ADDENDUM NUMBER 2

- 1.01 DATE: NOVEMBER 23, 2020**
- 1.02 PROJECT: ELMORE SPORTS MEDICINE RENOVATIONS**
- 1.03 PROJECT NUMBER: DCM NO. 2020452**
- 1.04 OWNER: ALABAMA A&M UNIVERSITY**
- 1.05 ARCHITECT: NOLA | VAN PEURSEM ARCHITECTS, PC**

SHEET NUMBER
A-6.1
OF

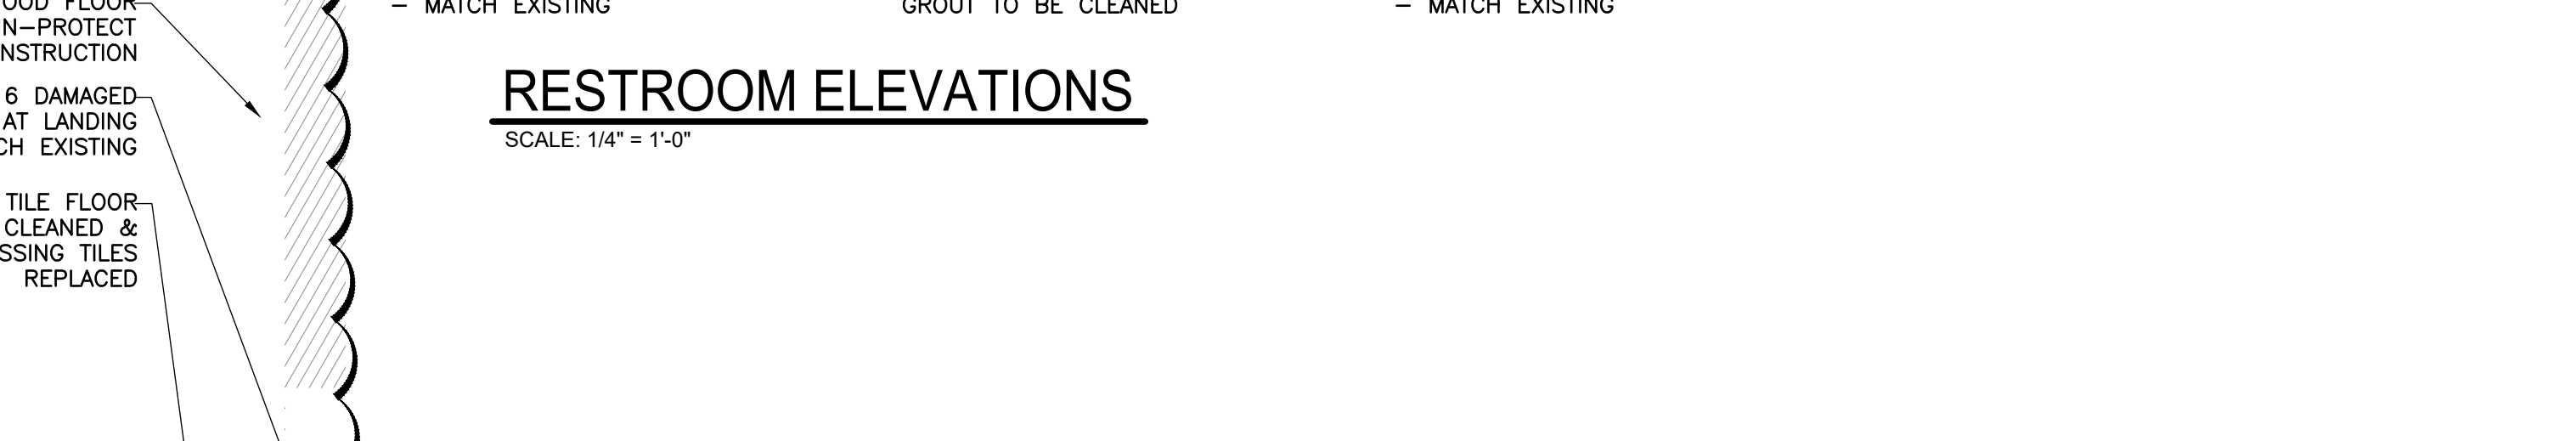
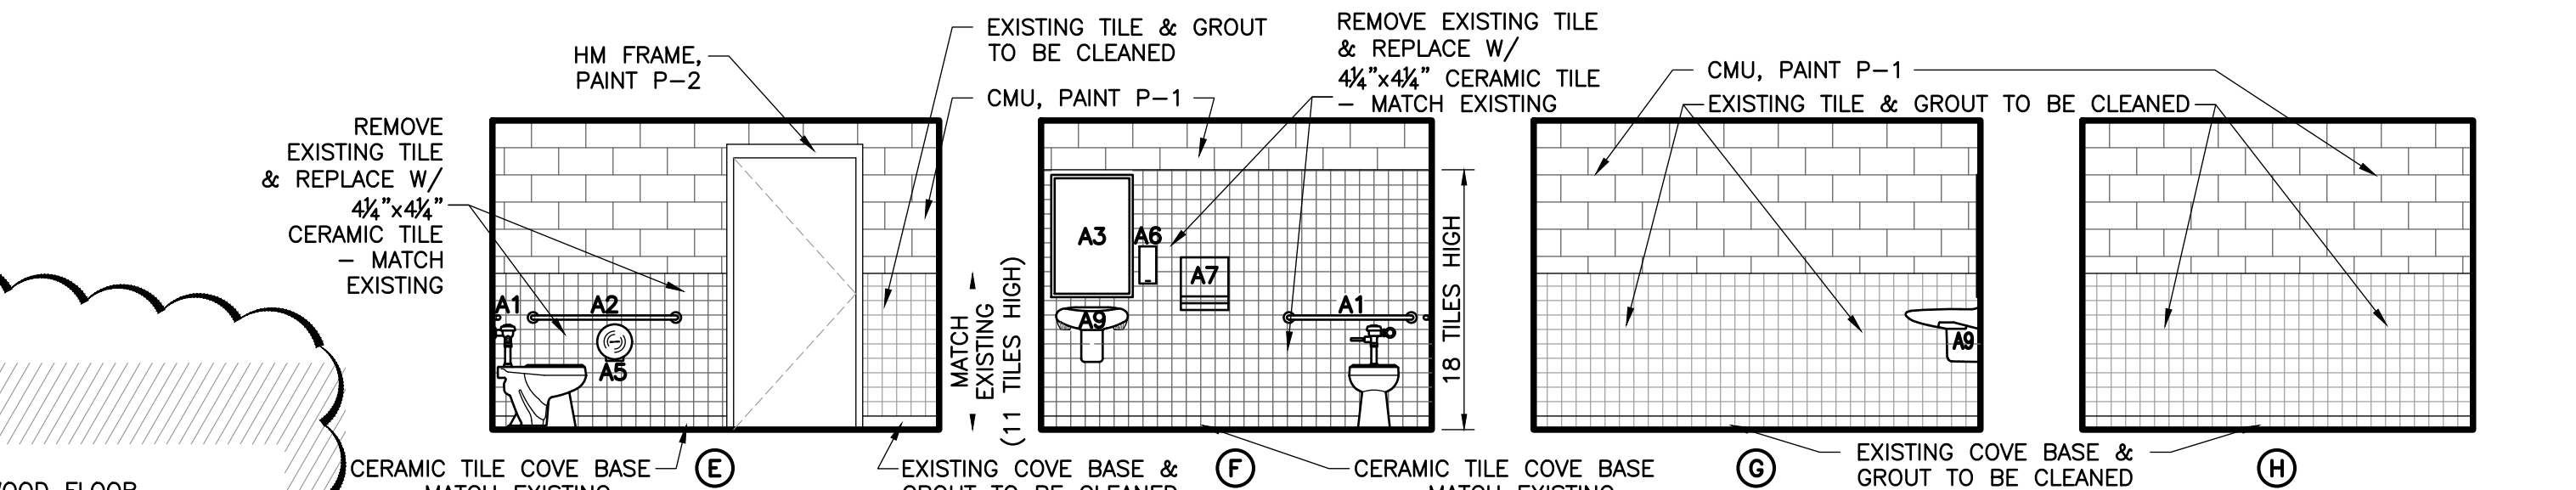
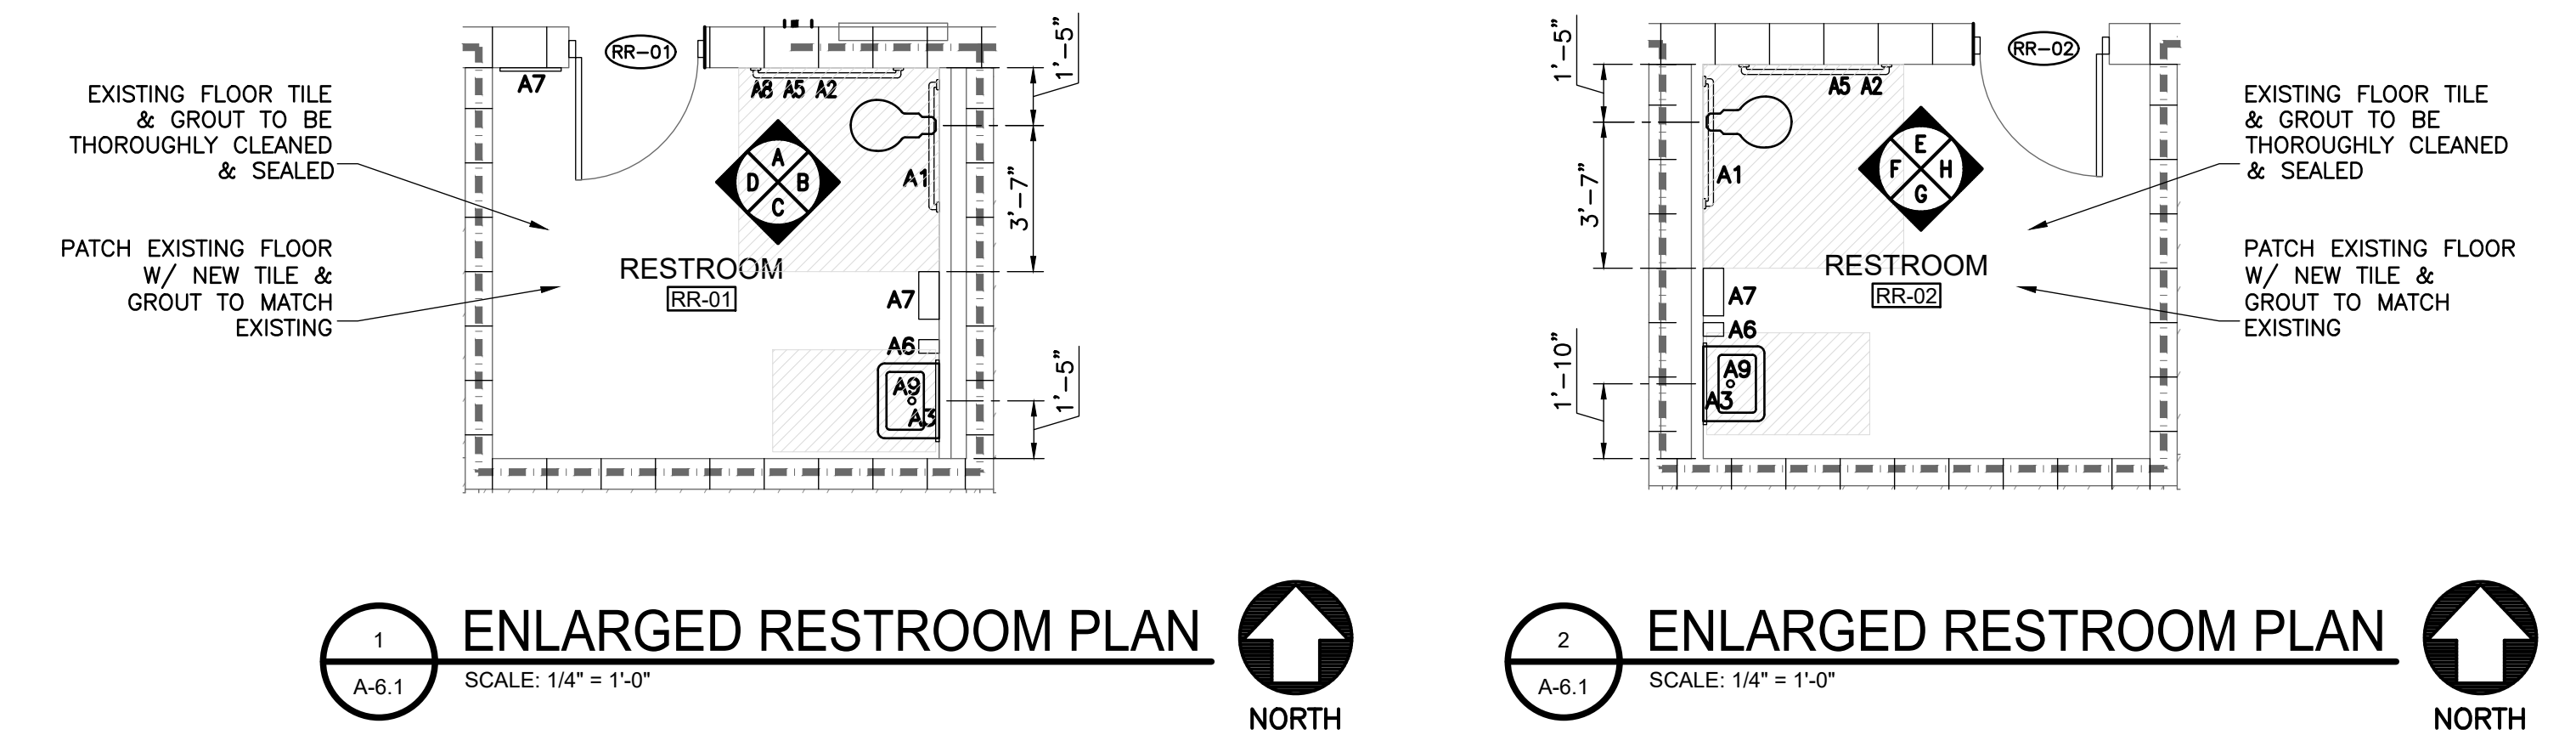
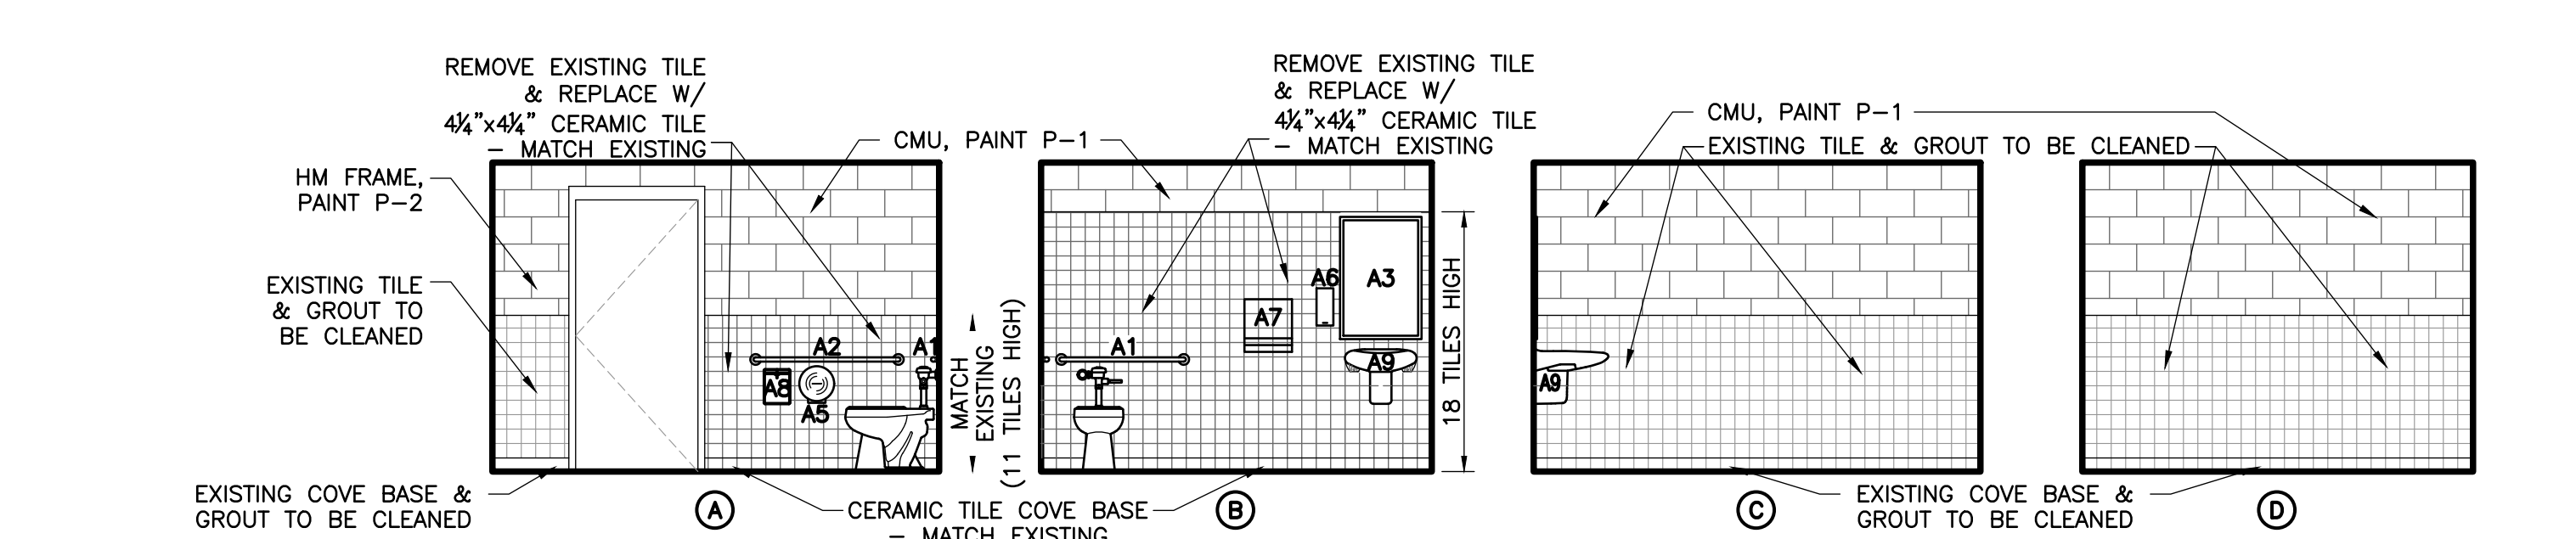
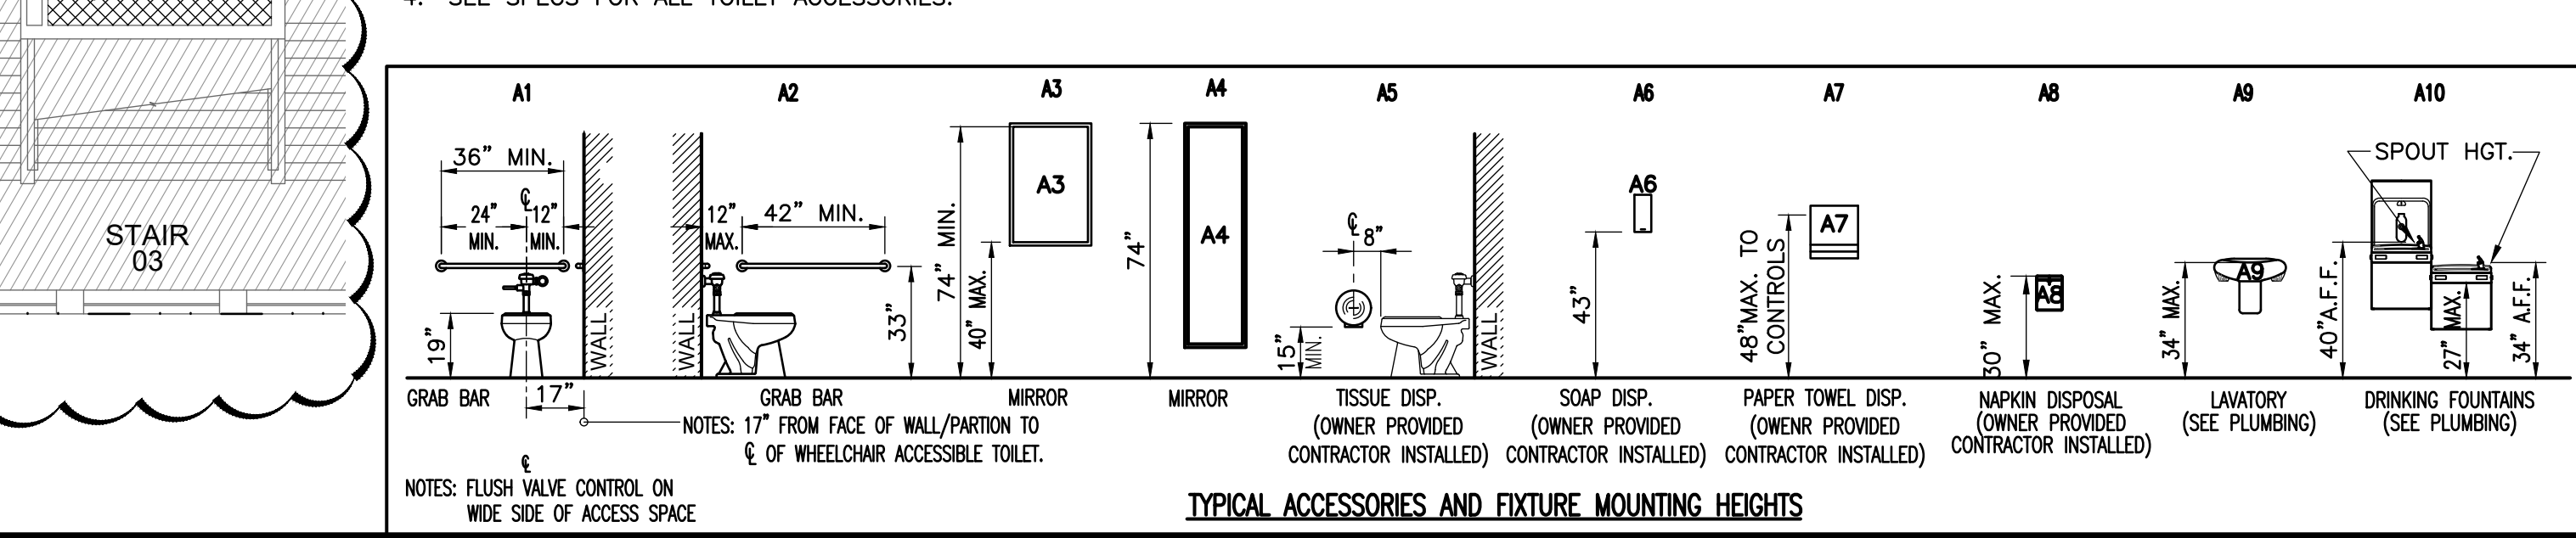
- A. Replace this sheet in its entirety. Revisions include the following:
 - 1. Added enlarged laundry plan and elevations.
 - 2. Added floor finish plan mezzanine.
 - 3. Added floor finish plan lobby.
